LOT: 15
BLOCK : 7007
SUBDIV: CELEBRATION CAPE
ADDRESS: 211 DESTINY CIRCLE
G.C.D. JOB #: 7977

MODEL: UNIT 1983
RESIDENCE FOR: SPEC

DATE: 7-22-14
DRAWN BY: GCH
CHECKED BY: JWC
REVISED:
PLAN: FOUNDATION
SCALE: 1/4"=1'-0"
SHEET# A-2

FOUNDATION PLAN SCALE: 1/4" = 1'-0"

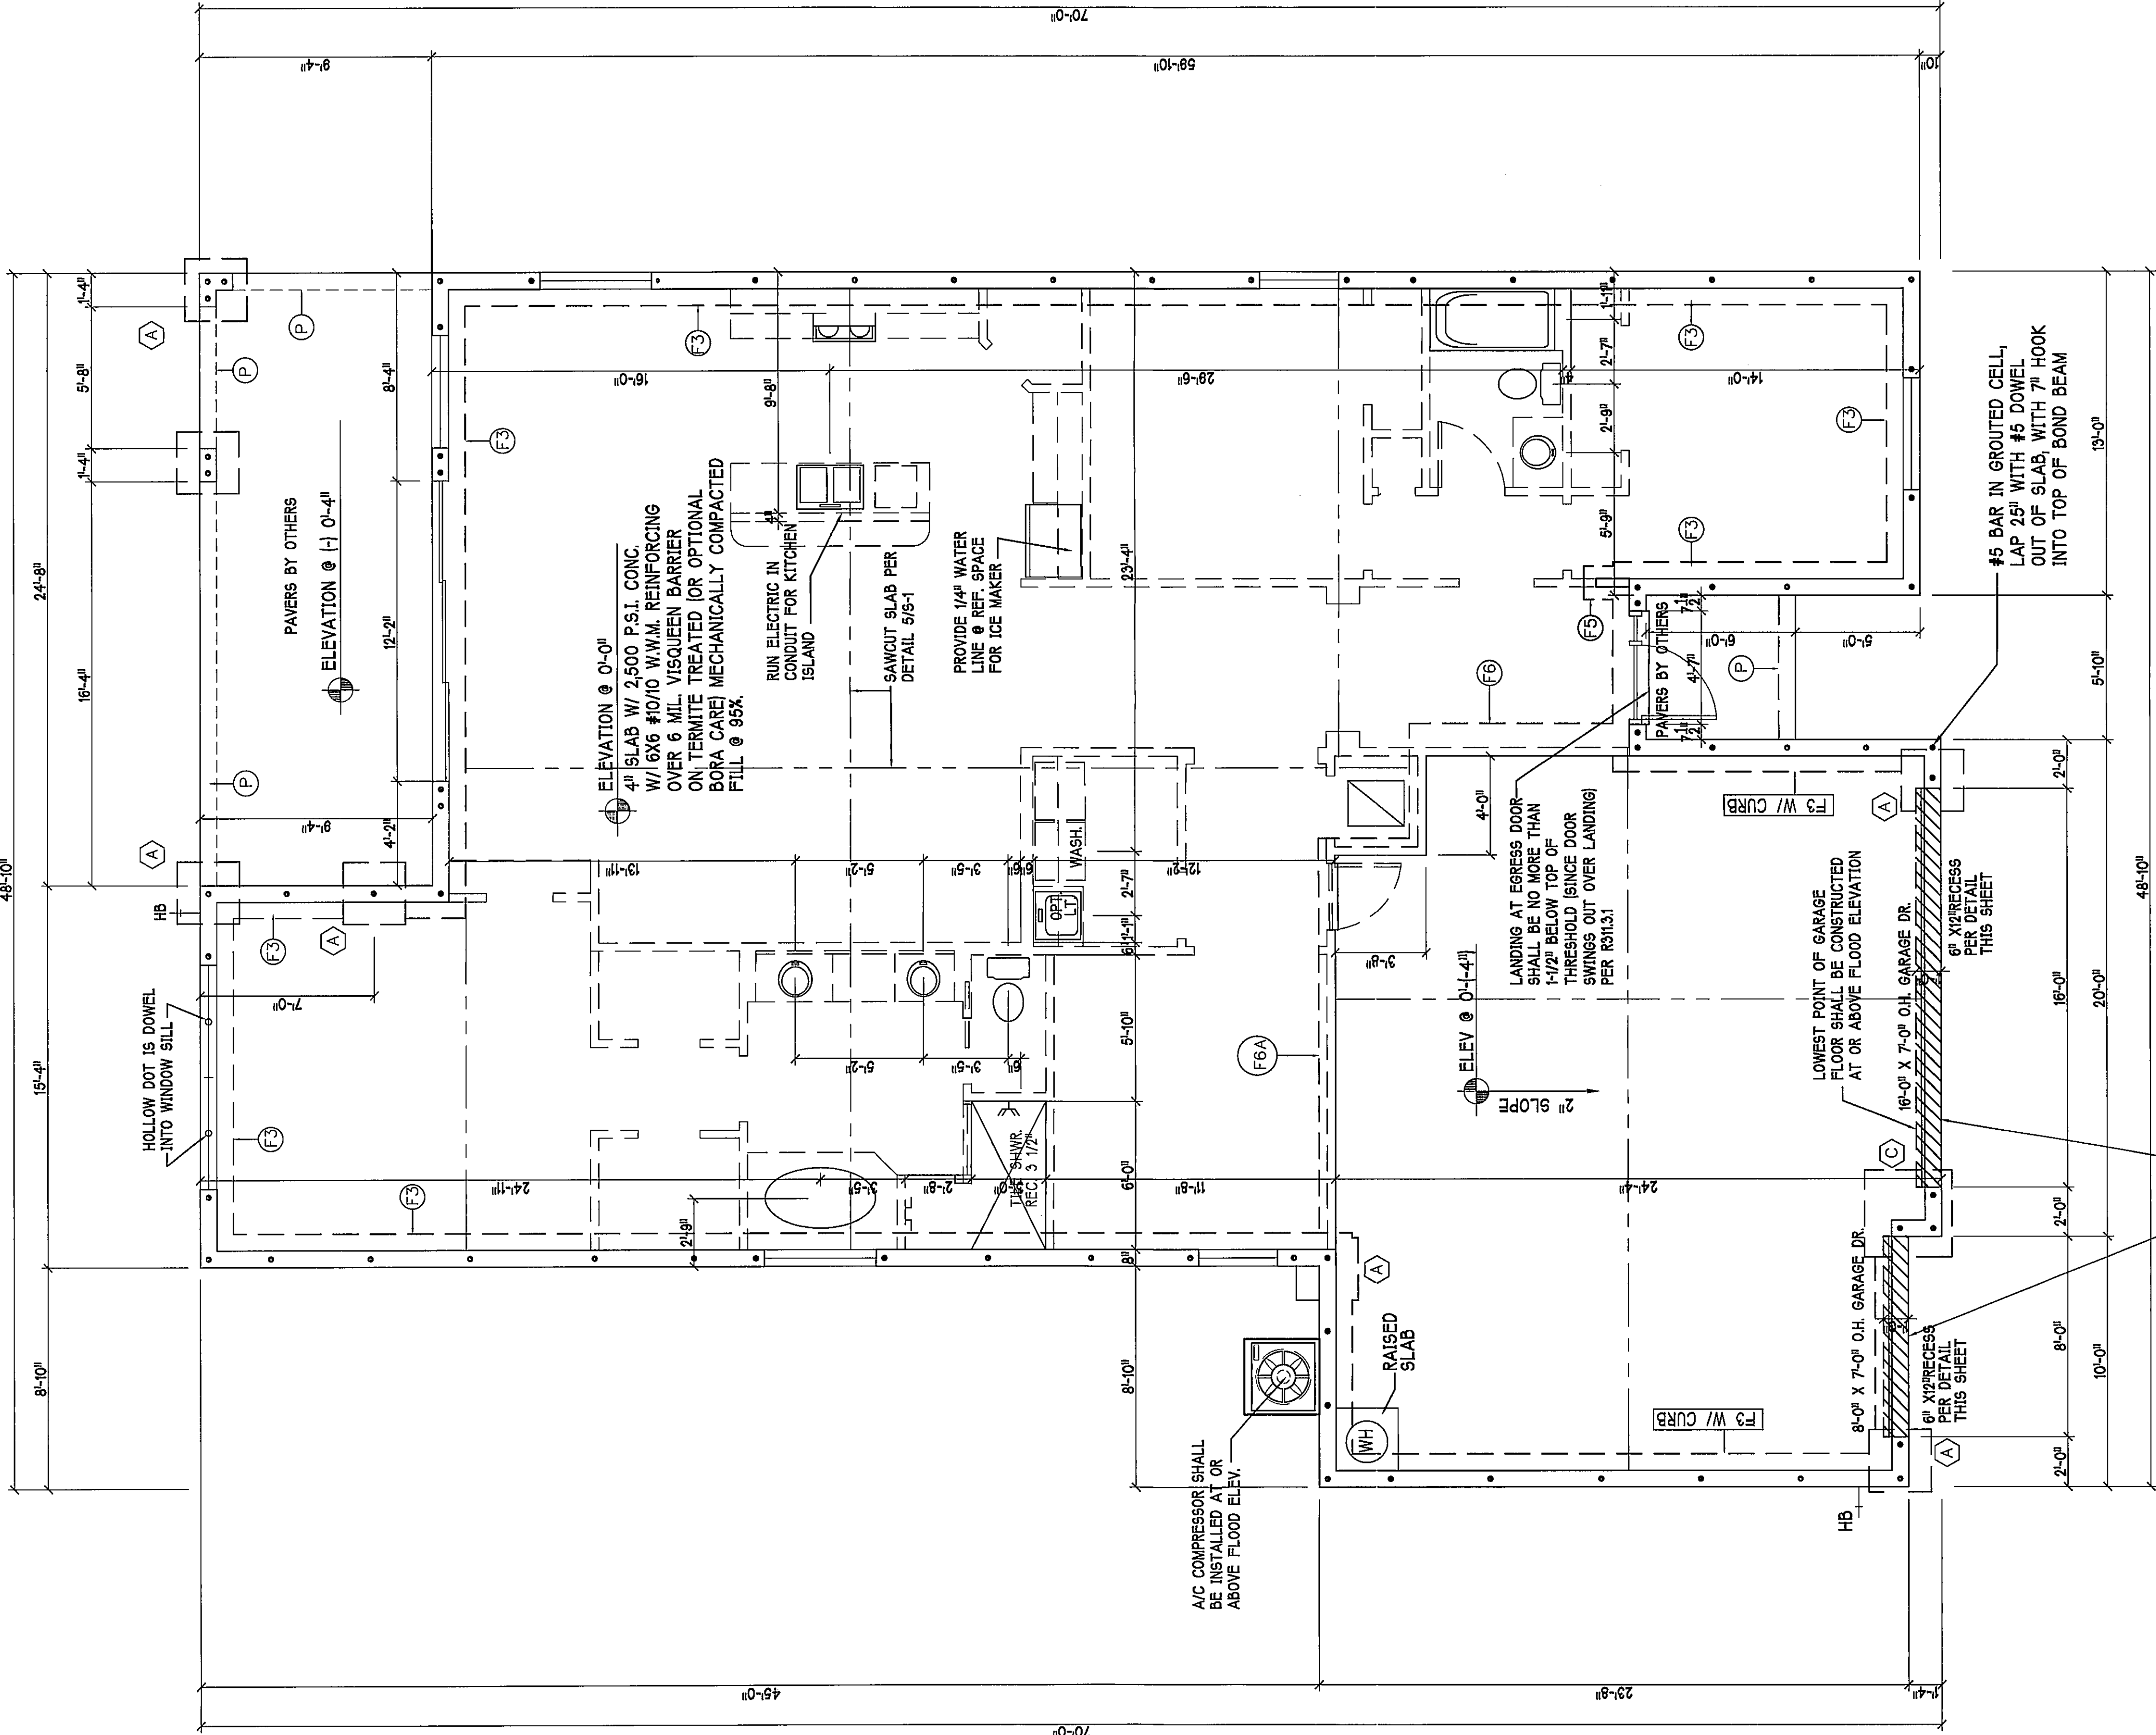
8F8-1B SET AT GARAGE DOOR RECESS, TO 8X8 BOND BEAM W/ 1 #5 TOP @ 9'-4". ADD #5 VERT @ 48" O.C. GROUT ALL SOLID.

ADD CURB TO GARAGE, SEE DETAIL

WEEP SCREED DETAIL

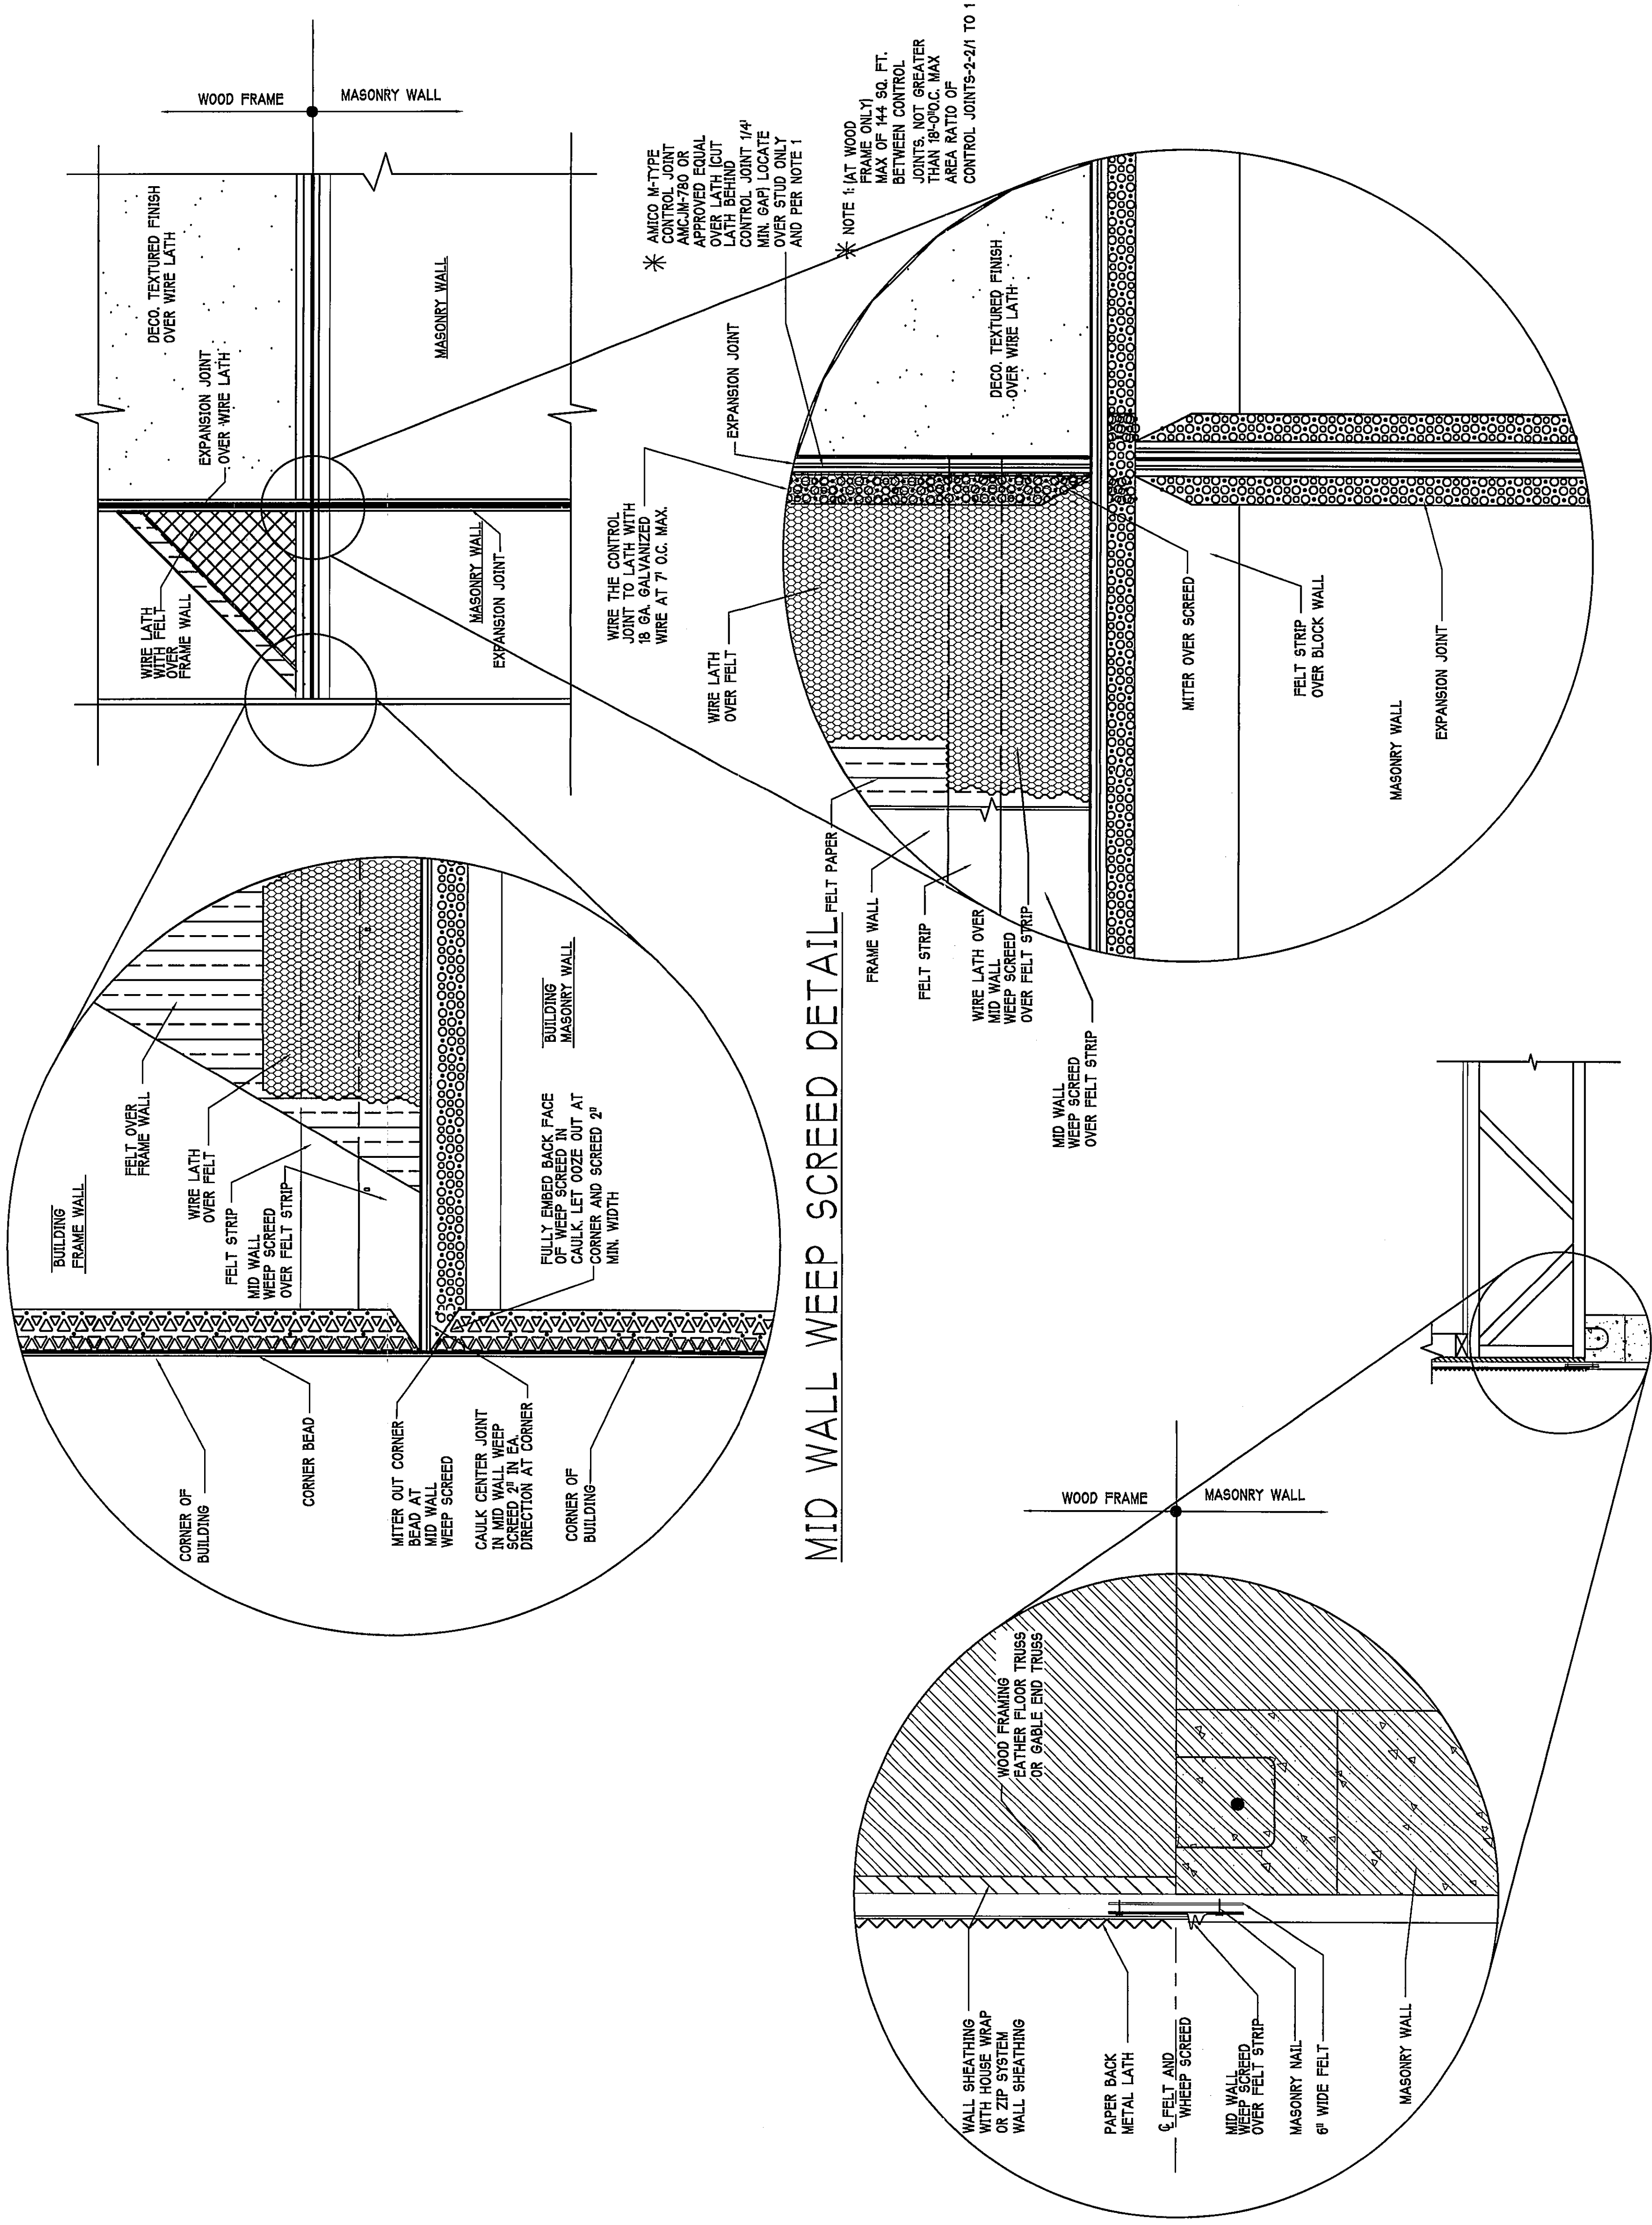
**NOTE: CROWN BANDING MUST RETURN
10'-0" ON SIDE ELEVATION & RETURN
TO ENTRY**
